Rep No.B18075

Fuji Electric FA Components &  
Systems Co., Ltd.

## Notification regarding Change to the External Operating Handle of Molded Case Circuit Breakers and Earth Leakage Circuit Breakers

**Driver unit**

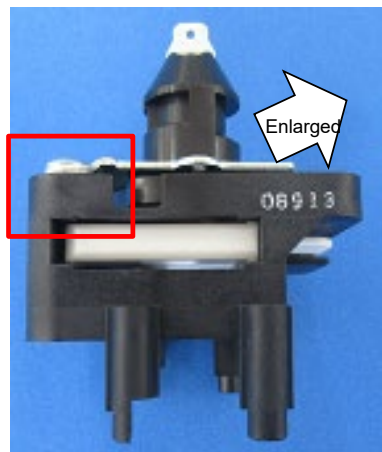
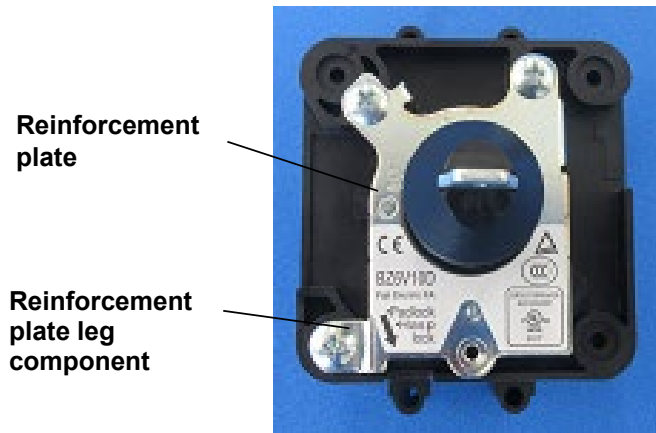
Conventional product	Changed product
<p data-bbox="1025 767 1122 794"><b>Spacer</b></p> 	 <p data-bbox="1435 1161 1861 1241"><b>The shape of the reinforcement plate leg component will be revised, and the spacer removed.</b></p>

Attachment 3  
Screw Bag Label Specification Change

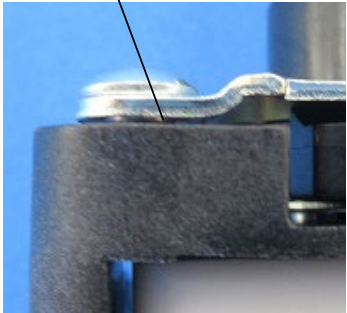
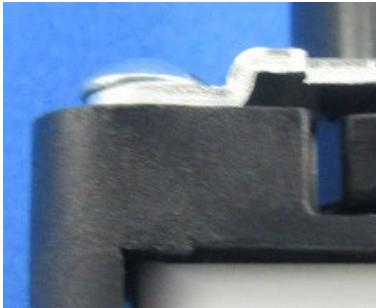
Conventional product	Changed product
	 <p data-bbox="1442 807 1525 858">Addition of type</p> <p data-bbox="1346 1118 1491 1169">Addition of our control number</p>

Attachment 2  
Details of Front Nameplate Specification Change

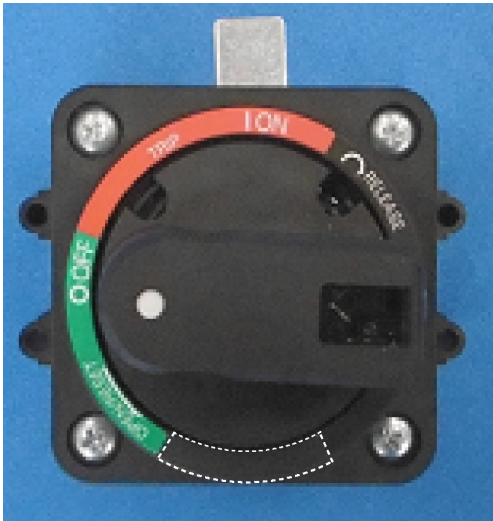
Conventional product	Changed product
 <p data-bbox="517 1082 1016 1353"> Conventional front nameplate</p>	 <p data-bbox="1144 1123 1424 1289">Removal of the part indicated by the dashed lines from the front nameplate (Solid black part)</p>  <p data-bbox="1619 1305 1832 1367">Front nameplate after change</p>
